CLEPA inputs for 12th VRU-Proxi IWG 26-28 November 2019

STATUS ON REVERSING MOTION

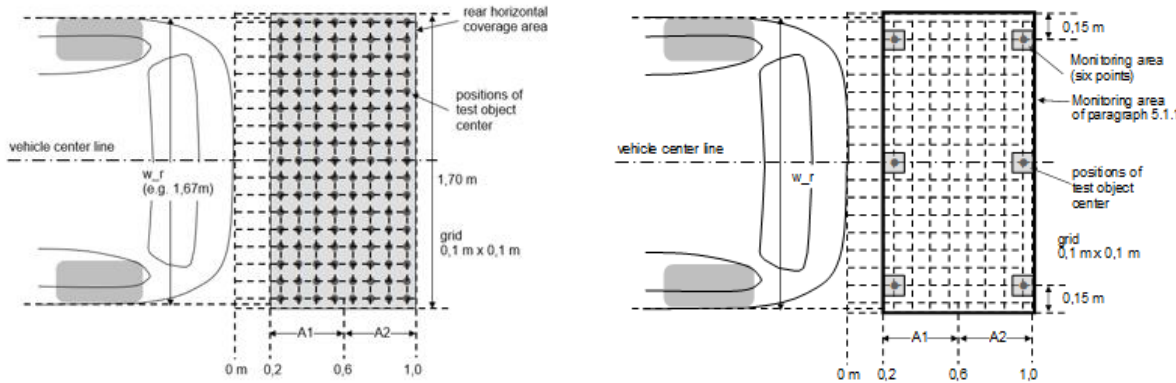
GSR with focus VRU!

According test object is considered in a.) BSIS (Blind Spot Information System)

Most probably will be considered in b.) MOIS (Moving Off Information System)

Reference: VRU-Proxi-11-08

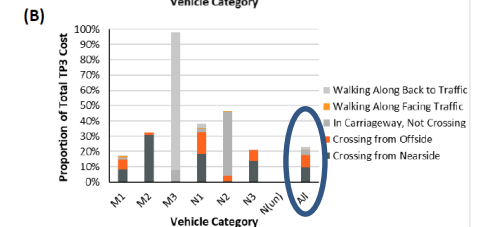
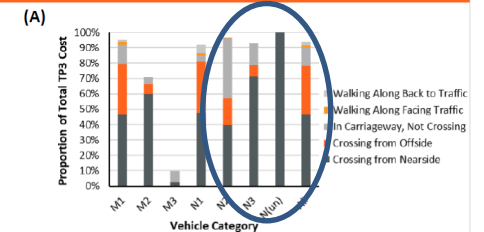
5.) No consideration of crossing scenario

- It was remarked that accident statistics indicates that moving pedestrian (crossing at the rear) ought to be addressed as Reversing Motion scenario. Chair took notice and proposed after consideration to move this to a second phase in order to avoid jeopardizing the deadline for submission of the draft regulation (April 2020). UK, J, F and the Industry agreed.

Abbildung 4: Überwachungsbereich (erforderliche Detektionsbereich) RAS-V2: 5,5 m und RAS-V1: 9 m (Draufsicht)

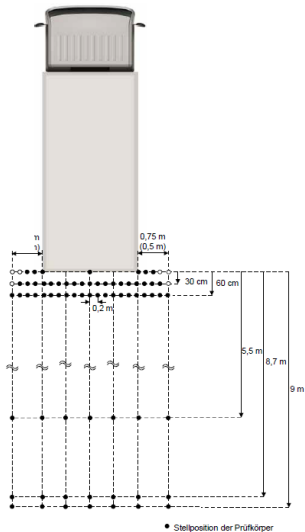
4.) Detection range (ISO 17386:2010) => focus on existing PC applications using USS

To use CV relevant detection ranges (e.g. 0,3m.....2m) / Input from GS-VL 40 or ISO/TR 12155

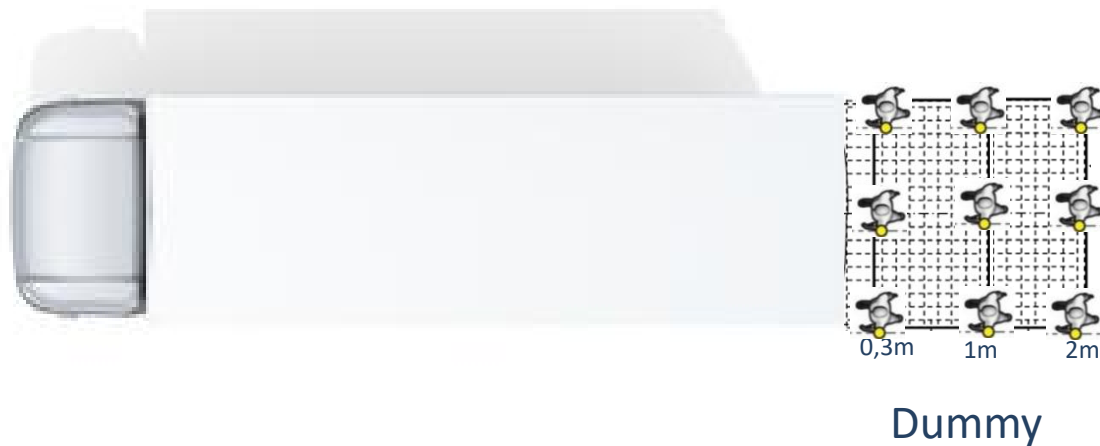
Combination of Test object 3.) and detection range 4.) for categories M2, M3, N2, N3

- Poles or Dummy can be used
- Increased detection range

VRU-Proxi-11-15 DRAFT
22 October 2019

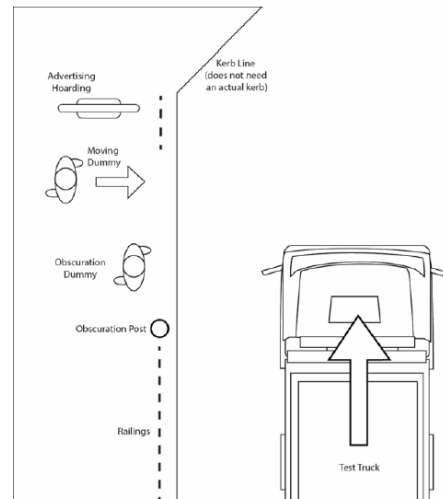
5.) No consideration of crossing scenarios

To use crossing scenarios comparable to MOIS or AEB VRU systems (PC)

- Outcome of discussions (all depending on the scenarios, speeds/locations):
 - Include pedestrians (adults and children) crossing/moving from nearside and offside with no obstructions;
